DESIGN CONTROL REVIEW

BUILDING STATISTICS	
REG. PLAN No.	65M-4737
ZONE	RWS2
LOT NUMBER	LOT 163
LOT AREA (m²)	343.75
BLDG AREA (m²)	157.75
LOT COVERAGE (%)	45.89%
MAX HEIGHT (3.5 STOREYS)	
No. OF STOREYS	2 STOREYS

PROJ. No. 20-31 MUNICIPAL ADDRESS

LOT No. 163 CURRENT DRIVE

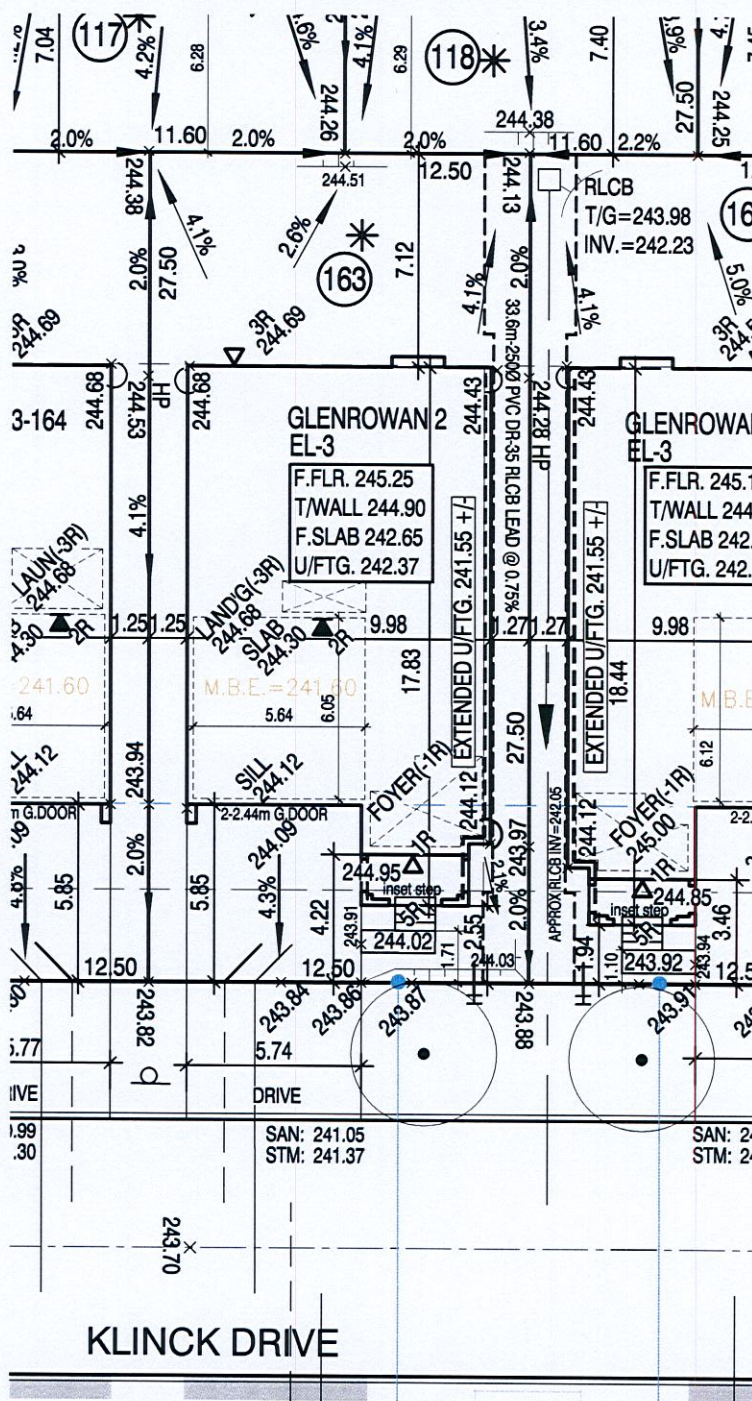
45 MINUTE RATED WALL WITH SIDE YARD < 1.2m
